Item 5.**Development Application: 183-187 Harris Street, Pyrmont - D/2025/1163****File Number: D/2025/1163****Summary**

Summary Recommendation: This proposal is recommended for refusal.

Figure 10: Proposed second floor plan

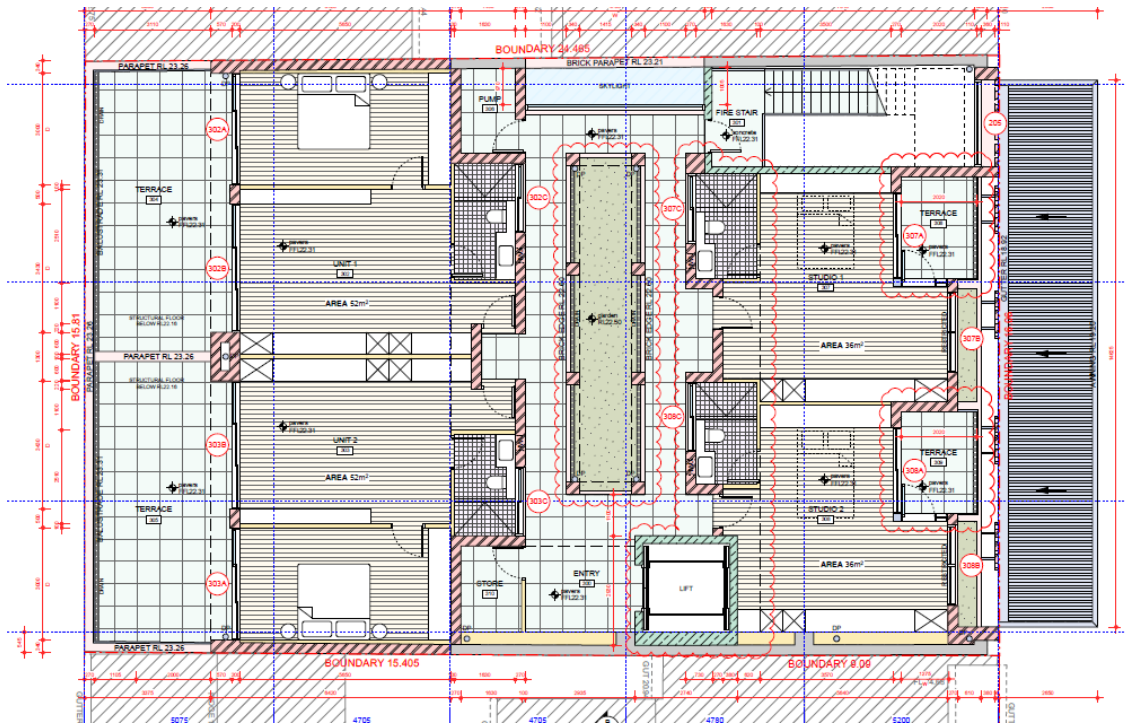
3D Communal and Public Open Space	Consistency	Comment
Communal open space has a minimum area equal to 25% of the site.	No	The communal open space landscaping between the apartments amounts to 4.8% of the site.
Developments achieve a minimum of 50% direct sunlight to the principal usable part of the communal open space for a minimum of two (2) hours between 9am and 3pm on 21 June (midwinter).	No	The communal open space is not useable for activities and is only used as landscaped area within the communal access area between the apartments. Direct sunlight can only access the space at 1pm-2pm on 21 June for 1 hour.

4.2.3.7 Private open space and balconies	N/A	See the ADG assessment above.
4.2.3.8 Common open space	No	The site does provide 4.8% of communal open space instead of the 25% as required by the control.

Figure 17: Existing cross section with central roof form exceedance over the 9m building height limit highlighted in yellow

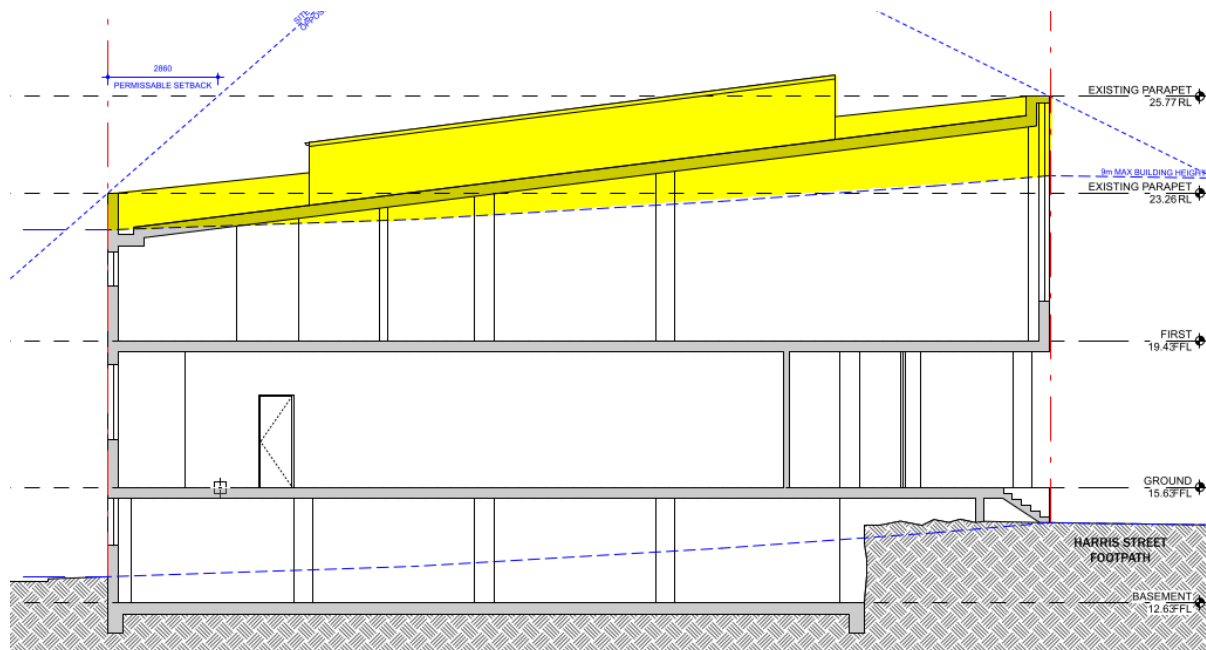
70. The existing exceedance of the 9m height control is primarily formed by the centralised non-habitable roof form and the lift overrun/stairs as shown in the figures 17 and 18 below. Figure 19 clearly depicts the 2 main areas (lift overrun/stairs and central roof form) that gives rise to the main areas of the existing exceedances. Figure 20 depicts the new bulk added to the top of the building because of the new roof form and additional storey.

71. The additional storey with the new roof form will generate additional bulk across the whole roof plane and have tangible bulk and massing impacts when viewed from the Little Mount Street and Harris Street. There will be visual bulk and additional massing even if the design attempts to achieve built form below the existing building height.
72. Objective 4.2.1.1(a) states:
- (a) Ensure the height in storeys and street frontage height in storeys reinforces the existing or future neighbourhood character*
73. The development is contrary to the objective as the existing and future neighbourhood character as the current controls and buildings are comprised of single and two storey buildings (as shown in figure 22) and as per the Pymont Ultimo Planning Proposal, there are no plans to allow this subject site or this streetblock to have higher densities.

Figure 23: Existing building floor to floor ceiling heights

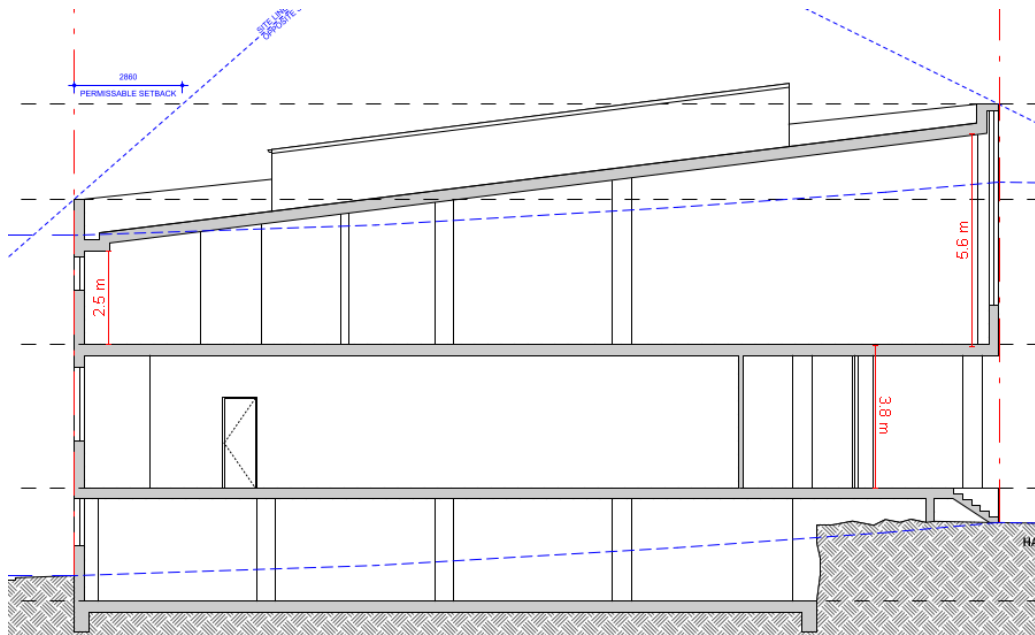
74. The floor-to-ceiling design criteria of the Objective 4C-1 requires the ground floor and the first floor of a mixed use development to be 3.3m.
75. The existing building has floor to floor heights of 3.8 metres at the ground floor and between 2.5m to 5.6m at the first floor. See figure 23 below.

Figure 24: Proposed building floor to floor ceiling heights.

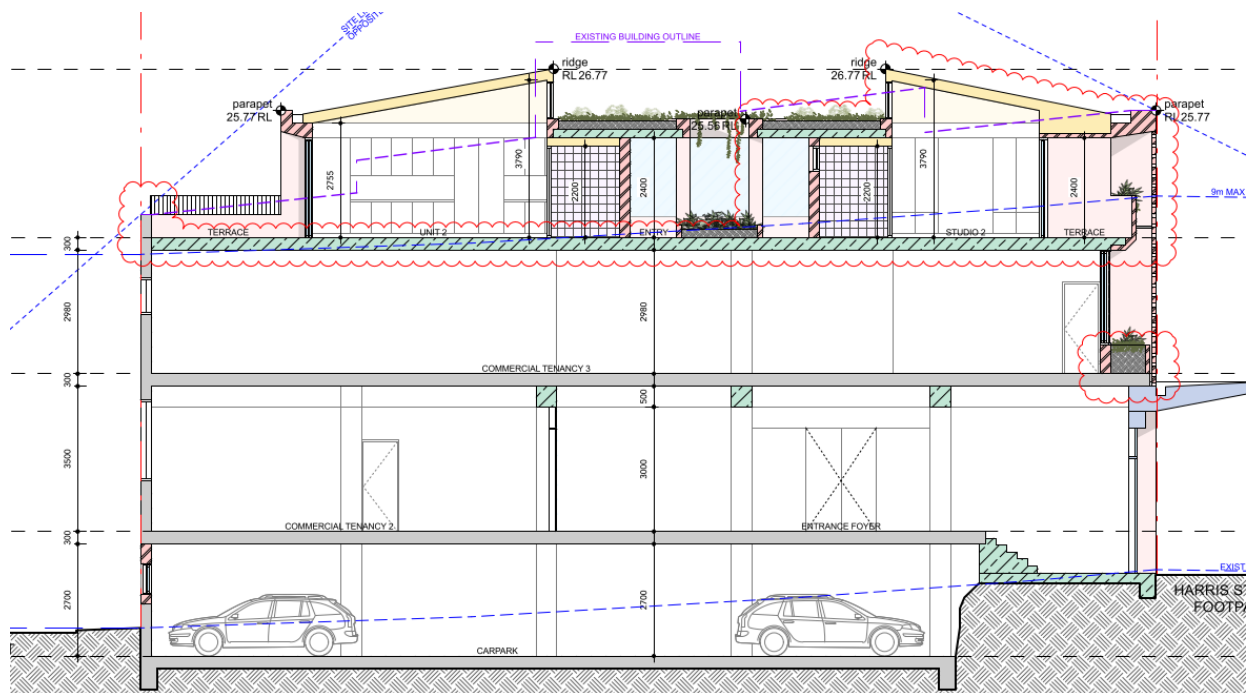
76. The proposed development has a floor-to-ceiling height of 2.98m at first floor. See figure 24 below.

77. The proposed development retains the ground level and basement floor to floor as existing, but compresses two additional storeys above, with the commercial first floor tenancy resulting in a non-compliant floor to ceiling height of 2.98m. This demonstrates the site cannot accommodate an additional storey without breaching the controls for bulk and massing on this site.
